REQUEST FOR ADDITIONAL INFORMATION

REGARDING SPENT FUEL TRANSFER

ENTERGY NUCLEAR OPERATIONS, INC.

INDIAN POINT NUCLEAR GENERATING UNIT NOS. 2 AND 3

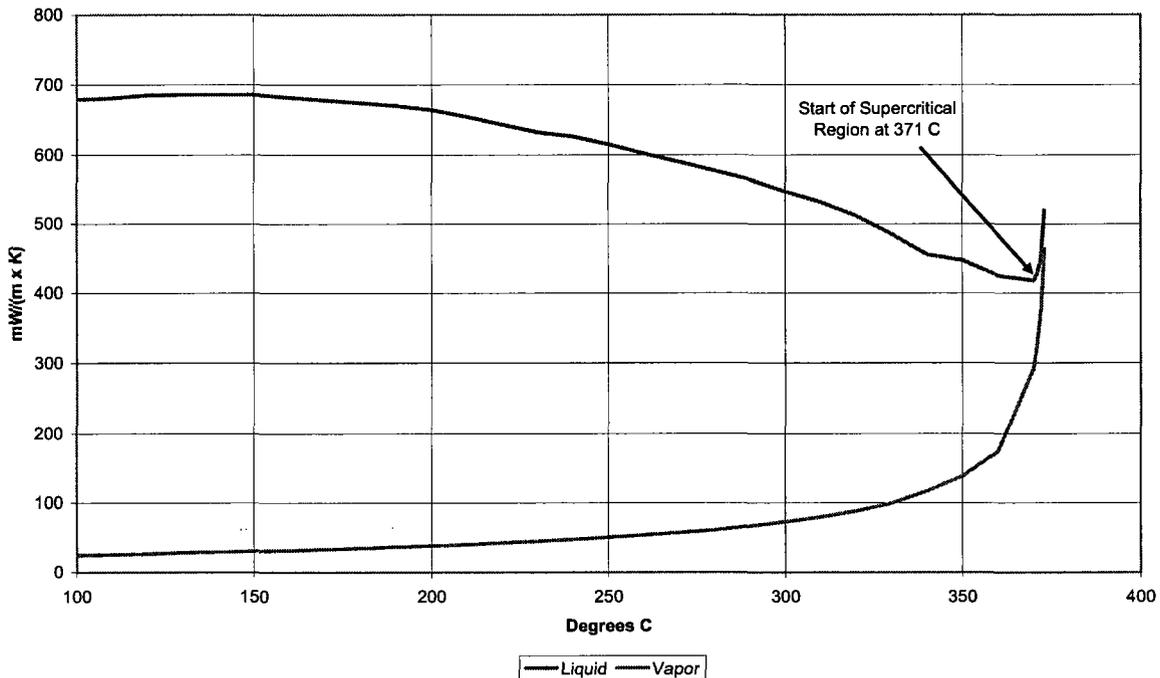
Review the thermal properties used to determine the thermal conductivity of saturated water vapor as a function of temperature. (TCB)

Page B-7 of Holtec report HI-2084146 provides saturated vapor thermal conductivity as a function of temperature. Thermal conductivity values tabulated at 371 C and 372 C appear to correspond to saturated liquid water. This may increase the effective conductivity at these temperatures.

Figure 8-4.1 Completed Shielded Transfer Canister at Holtec Manufacturing Division

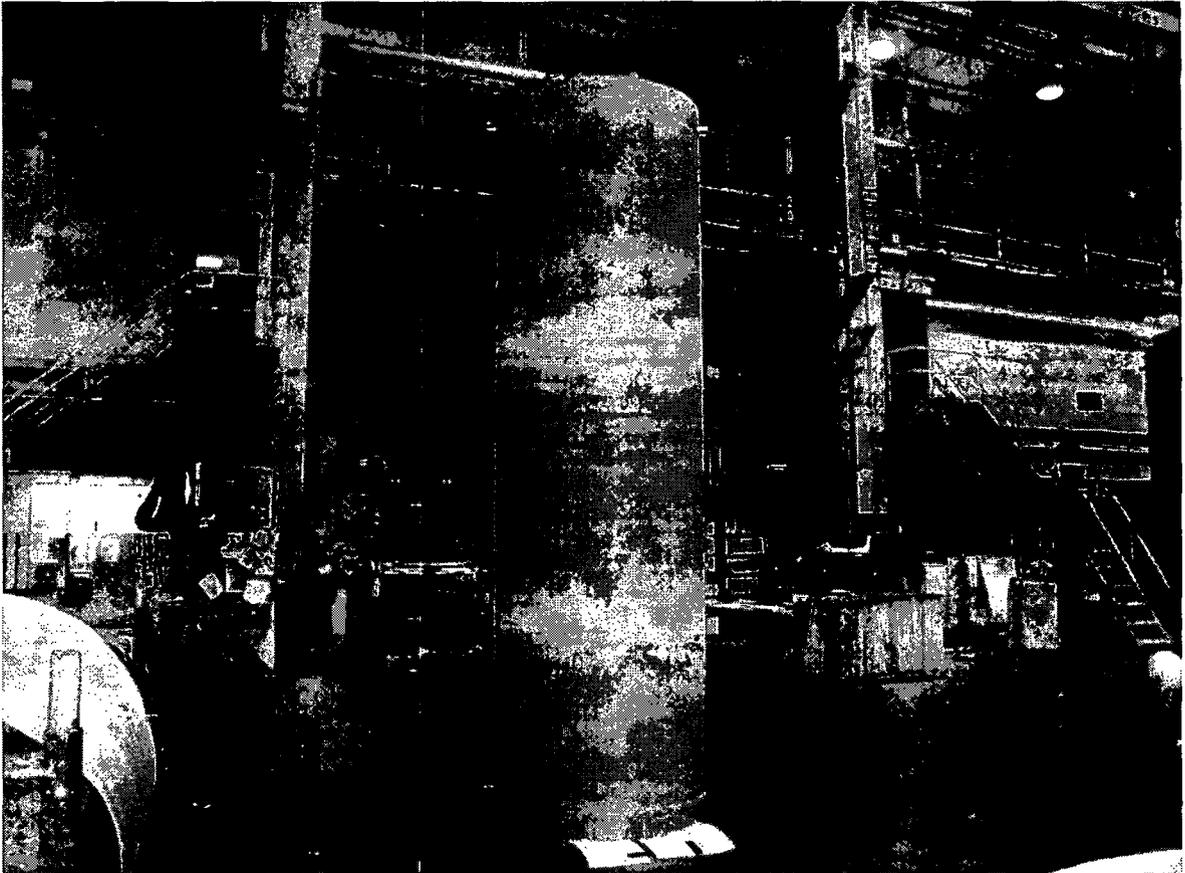
The allowable stress intensities of NC-3200 are greater than the allowable stresses of NC-3300/ND-3300 and, therefore, enable the designer to reduce the thickness of the vessel. The STC, however, is conservatively designed to meet the lower allowable stress limits of NC-3300/ND-3300 with significant additional margins of safety. A photo of the fabricated STC is shown in Figure 8-4.1 at the end of this RAI response.
